Product Change Notification / SYST-30XUJC204

ERRATA - PIC18F04/05/14/15Q40 Silicon Errata and Data Sheet Clarifications

Description of Change: Adding silicon revision E0. Adding silicon errata 1.3.2, 1.3.3, 1.3.4 and 1.7.1.

1.4.1 UART TXDE Signal May Go Low Before the STOP Bit Has Been Entirely Transmitted

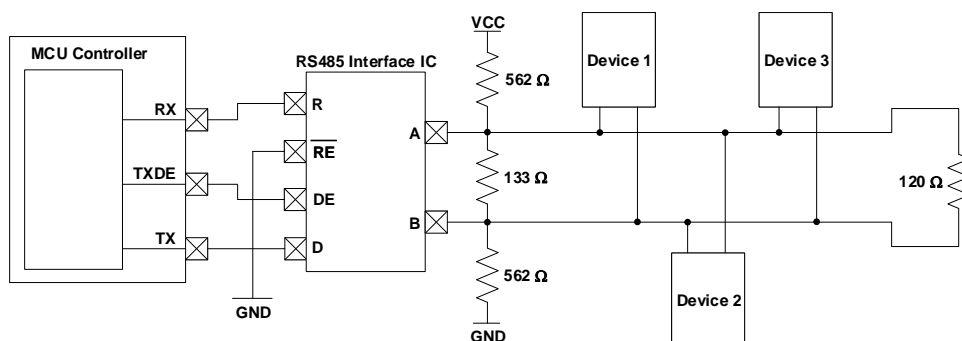
The UART Transmit Drive Enable (TXDE) signal could potentially transition into a low state before the UART STOP bit has been entirely transmitted due to the effects of parasitic capacitance on the TX line. In some applications, this could result in communication being prematurely terminated due to the TXDE bit going low before the STOP bit has had enough time to settle.

To ensure that the STOP bit settles into its final logic state before the TXDE signal transitions low, a biasing circuit can be implemented. A biasing circuit allows the TX line to either be driven high or low, rather than being left in a floating tri-state mode where prolonged rise or fall times could lead to communication being disrupted. This bias circuit should only be implemented on one end of the serial bus, and a termination resistor should be used on the other end. The figure below show an example of a bias circuit that can be used to achieve this.

Please note that the resistor values used in this circuit are recommendations, and that the actual resistor values required may vary based on the application.
